**SOUTHERN RURAL WATER AT'S NELSON COX
VCAT PROCEEDING NO. P2316/2008
HEARING: 2 FEBRUARY 2009**

Groundwater Resource Assessment of Deeper Aquifers in the Lindenow region, East Gippsland

REVIEW OF THE SKM LINDENOW STUDY (2007) AND RECOMMENDATIONS
Prepared by Manager Water Resources and Environment November 2007

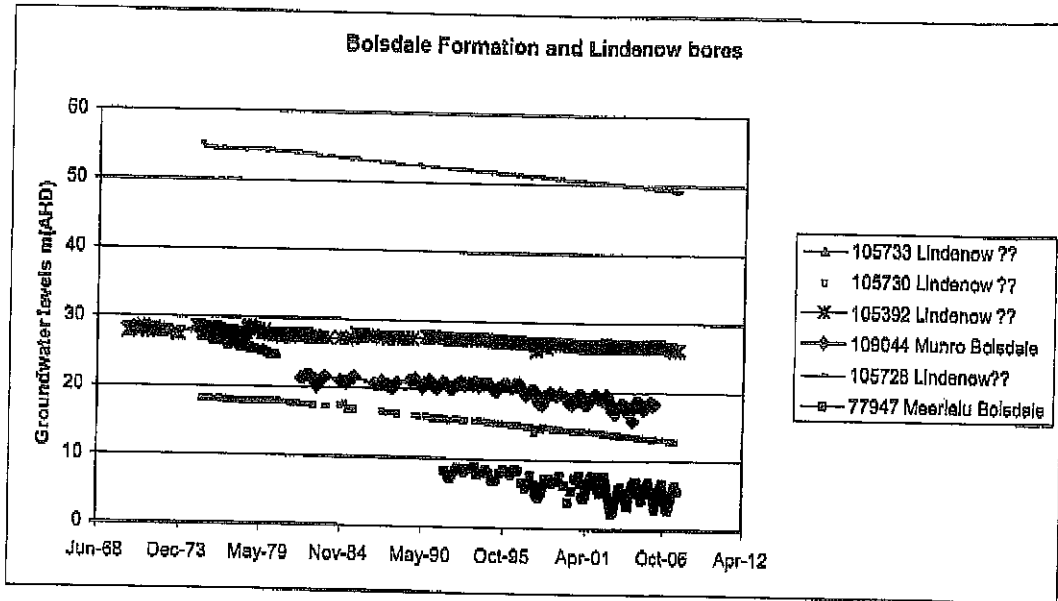
To further analyse the issue of relationship to other aquifers, hydrographs screened in the Latrobe Group and Boisdale Formations outside the study area were compared to the Lindenow hydrographs.

The Lindenow bores are in a decline but not at the same rate as the Latrobe Group. The deepest of the Lindenow bores 105733 (260m) near Wy Yung has no measurement since 1980 and a steeper decline more like the Latrobe Group aquifer. A comparison with the Balook/LVCM bores is not included because it is difficult to differentiate from the Latrobe Group and there is a strong connection between these aquifers

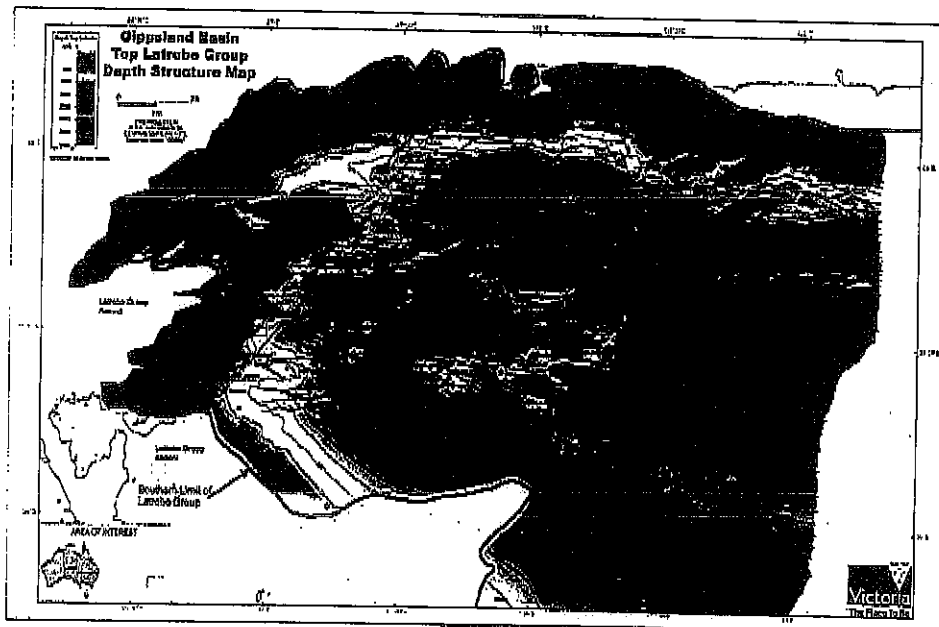
Comparison with the Boisdale Formation bores shows a similar change in levels over the same period. A feature of the Boisdale bores is that prior to 1997 the trend is relatively flat with a step and decline post 1997. This change is not apparent in the Lindenow bores.

Based on the SKM cross sections and the hydrographs there is sufficient reason to believe the Lindenow aquifers are not in direct connection with the Boisdale Formation but are declining at a similar rate.

**"Gippsland Basin Top Latrobe Structure Map (1:1,000,000)",
Department of Primary Industries**

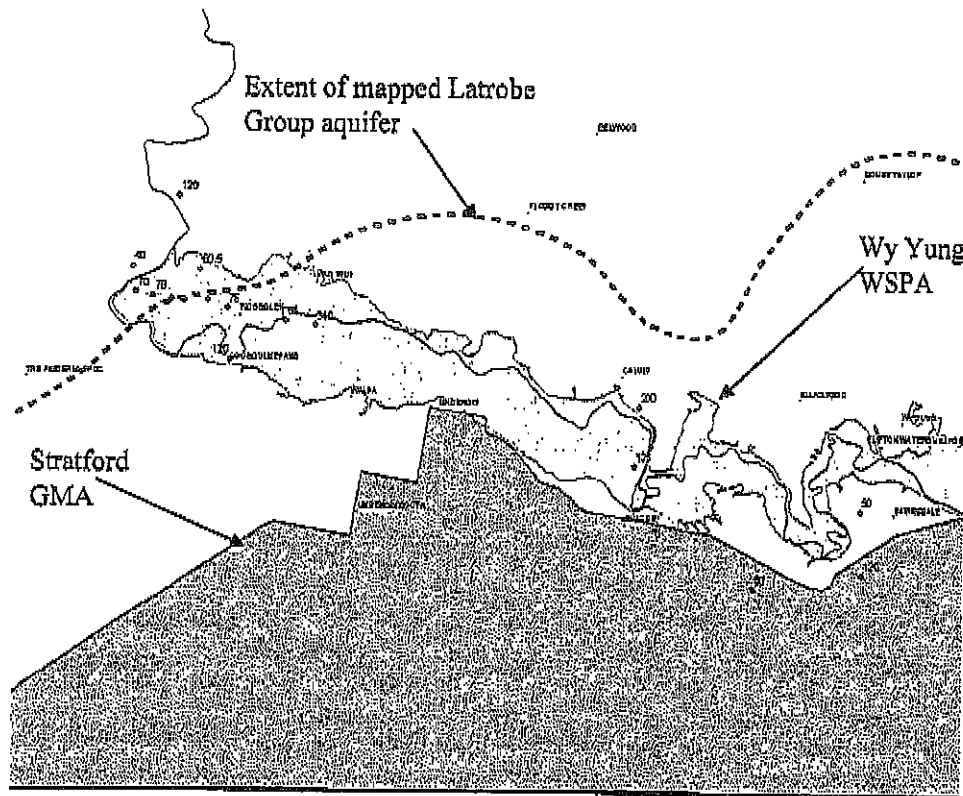
The SKM report concludes it is most likely the Lindenow aquifer is a part of the LVCMBalook formation and in connection with the regional Latrobe aquifer system

The differentiation between the LVCM/Balook and the Latrobe Group in Lindenow is academic. The concern with the Lindenow aquifers is the underlying decline which has been occurring over the thirty years of recorded levels which suggests it is not a consequence of local groundwater pumping but that the aquifer is draining due to external influences. Mapping taken from DPI's website illustrates that nearly all of the Lindenow Flats overlie the Latrobe Group aquifer and that the aquifer comes towards the surface in this area. This is sufficient evidence that the bores are targeting regional aquifers. These regional aquifers are capped from further allocation.
